# Work Order ID 94359

Item Name: Crosstube Turning Detail

<b>DART AEROSPACE LTD</b>	<b>Work Order:</b>	94359
<b>Description:</b> Crosstube Assembly (412 Low Aft)	<b>Part Number:</b>	D412-664-249
<b>Inspection Dwg:</b> D412-664-249 Rev: B		Page 2 of 2

DRAWING NO. D412-664-249	TITLE CROSSTUBE ASS'Y (412 LOW AFT)	REV. B	<b>DART AEROSPACE LTD ENGINEERING ORDER</b>		D.E.O. NO. D412-664-249-B-1	SHEET NO. SHEET 1 OF 2	SCALE NTS
DRAWN <i>qp</i>	CHECKED <i>SC</i>	MFG. APPR. <i>R</i>	APPROVED <i>MD</i>		DE APPR. <i>MD</i>		
DATE 11.05.25	DATE 11.05.31	DATE 11.05.31	DATE 11/05/31		DATE 11.05.31

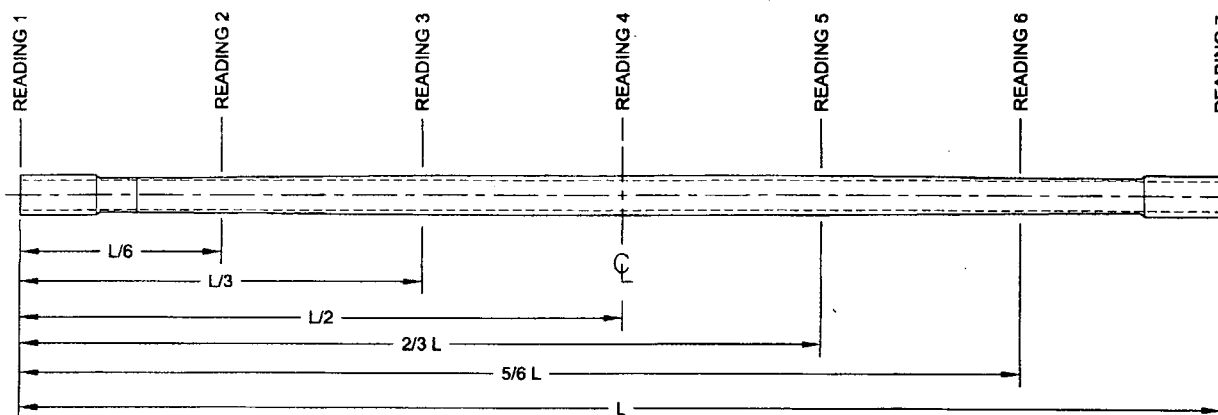
Root Cause	Date	Step	Qty	Description of work order update or Non-conformance	Initial Chief Eng	Action Description	Sign & Date	Verification	QC Inspector
Doc/Data <input type="checkbox"/>	<u>13/1/15</u>	<u>100</u>	<u>1</u>	<u>Tube has been cut too short, showing total length of 127.700"</u>	<u>DAS</u> <u>12</u> <u>9-88</u> <u>13/1/15</u>	<u>Overall effect on taper would be to effectively reduce O.D. by up to 0.001", by <del>O.D. measurement</del> shifting tapers. O.D. measurements are over nominal by 0.001" &amp; Acceptable.</u>	<u>13/1/15</u>	<u>13-1-16</u>	<u>17/1/23</u>
Equip/Tooling <input type="checkbox"/>									
Operator <input type="checkbox"/>									
Material <input type="checkbox"/>									
Setup <input type="checkbox"/>									
Other <input type="checkbox"/>									
Process <input type="checkbox"/>									
Supplier <input type="checkbox"/>									
Training <input type="checkbox"/>

Work Order: <u>94359</u>	<b>DISPOSITION</b> Rework <input type="checkbox"/> Scrap <input type="checkbox"/> Use-as-is <input checked="" type="checkbox"/> Work Order Update <input type="checkbox"/>	<b>AGAINST DEPARTMENT/PROCESS</b>			
Part No. <u>D412-664-209TRN</u>		Skid-tube <input type="checkbox"/> Machining <input type="checkbox"/> Thermoforming <input type="checkbox"/> Large Fab <input type="checkbox"/>	Crosstube <input checked="" type="checkbox"/> Small Fab <input type="checkbox"/> Finishing <input type="checkbox"/> Composite <input type="checkbox"/>	Water Jet <input type="checkbox"/> Prod. Eng. Coord. <input type="checkbox"/> Rec/Store/Packaging <input type="checkbox"/> Supplier <input type="checkbox"/>	Engineering <input type="checkbox"/> Quality <input type="checkbox"/> Other <input type="checkbox"/>
NCR No. <u>13-2241</u>

D412-664-249  
ASSEMBLY DETAIL

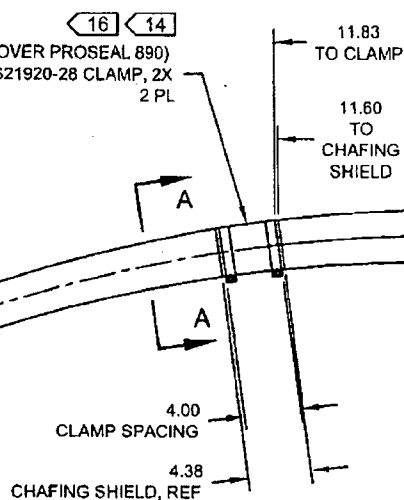
REMOVED ABRASION STRIP IN FAVOR OF A THIN LAYER OF PROSEAL 890. UPDATE INSTALLATION OF CHAFING SHIELDS AND REDUCE TORQUE TO 40-50 IN-LBS. THIS ENGINEERING ORDER SUPERCEDES DEO D412-664-249-B-1

NOTE 14 AND 16 ON SHEET 1 IS AMENDED AS FOLLOWS:

IS:

D3189-1 CHAFING SHIELD (1, INSTALLED OVER PROSEAL 890)  
MS21920-28 CLAMP, 2X  
2 PL

D412-664-609  
BENT TUBE

WAS:

D2856-600-1009 ABRASION STRIP  
D3189-1 CHAFING SHIELD (1, INSTALLED OVER ABRASION STRIP)  
MS21920-28 CLAMP, 2X  
2 PL
